**FIRE SAFETY FOLLOW UP INSPECTION**

<b>Factory Name</b>	ASWAD COMPOSITE MILLS LTD. ( U-2)		<b>Accord ID</b>	11095
<b>Address</b>	Kabirpur, Ashulia, Savar			
<b>Inspection Date</b>	05/08/2014		<b>Report Received Date</b>	21/April/15
<b>Date of 1st Follow-up</b>	17/November/15	<b>Date of 2nd Follow-up</b>	17/July/16	
<b>Date of 3rd Follow-up</b>	05/March/17	<b>Date of 4th Follow-up</b>		
<b>Date of 5th Follow-up</b>		<b>Date of 6th Follow-up</b>		
<b>Date of 7th Follow-up</b>		<b>Date of 8th Follow-up</b>		
<b>Date of 9th Follow-up</b>		<b>Date of 10th Follow-up</b>		
<b>Inspected by</b>	Nasif Javed Tofa

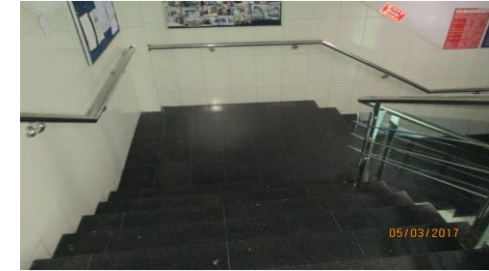
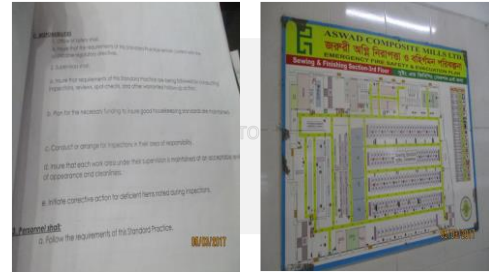
Item No	Accord Observation	Accord Recommendation	Timeline given by Accord	Comments after Physical Inspection	Supposed to complete(DD /MM/YYYY)	Final Action Plan (Factory)	Status on the date of Inspection	Pictorial Evidence
1	Exterior walls of Main Building-1 close to (less than 5 ft from) Ancillary Building-1 are penetrated for installing electrical cables from 3rd floor to ground floor. The penetrations are not sealed or protected. Moreover, non-rated openings are available on those exterior walls.	Provide fire-resistive rated opening and penetration protection for rated walls and assemblies in accordance with Alliance Standard Sections 4.6 and 4.7. Consult a qualified fire protection engineer to design the required opening protectives and penetration systems.	12/12/2014	On 17/11/16: In Progress. Factory has provided fire-resistive rated construction for side wall but non rated opening. Final CAP Timeline: Expired. Committed Timeline: Within 30th November 2015. On 17/07/16: Corrected. All unprotected open has been closed with proper fire rated wall. On 05/03/2017: Corrected. No unseal penetrations were observed during the time of inspection.	30/11/2015	Completed	Corrected

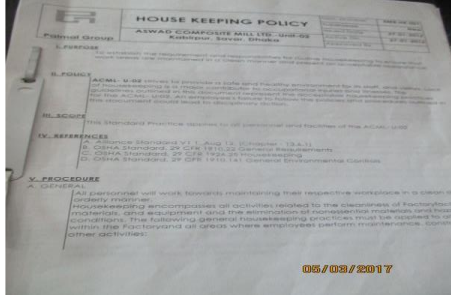
7	Some of the doors in the means of egress are collapsible.	Replace non-compliant doors and frames in the means of egress with side-swinging doors. Replacement doors shall be a minimum width of 0.8 m (32 in), and are listed, approved, self-closing, fire rated door assemblies (door and frame) with latching panic hardware.	21/11/2014	On 17/11/16: In Progress. Factory has removed all collapsible gates with locking arrangement except ground floor main gate. On 17/07/16: All non compliance gates has been replaced with side hinged swinging type doors. On 05/03/2017: All non compliance gates has been replaced with side hinged swinging type doors.	20/11/2015	Completed	Corrected	
8	There are collapsible gates with locking arrangement at some egress locations.	Remove all noncompliant doors at the noted locations. Doors may be locked where the latch and lock are disengaged with one motion where the occupant load does not exceed 49 persons. Turning a door handle and disengaging a lock are considered two motions. Doors may be provided with locking hardware from the ingress side provided that a panic bar is installed on any door with an occupant load exceeding 49 persons.	14/11/2014	On 17/11/16: In Progress. Factory has removed all collapsible gates with locking arrangement except ground floor main gate. On 17/07/16: Corrected. All non compliance gates has been replaced with side hinged swinging type doors. On 05/03/2017: Corrected. All non compliance gates has been replaced with side hinged swinging type doors.	20/11/2015	Completed	Corrected
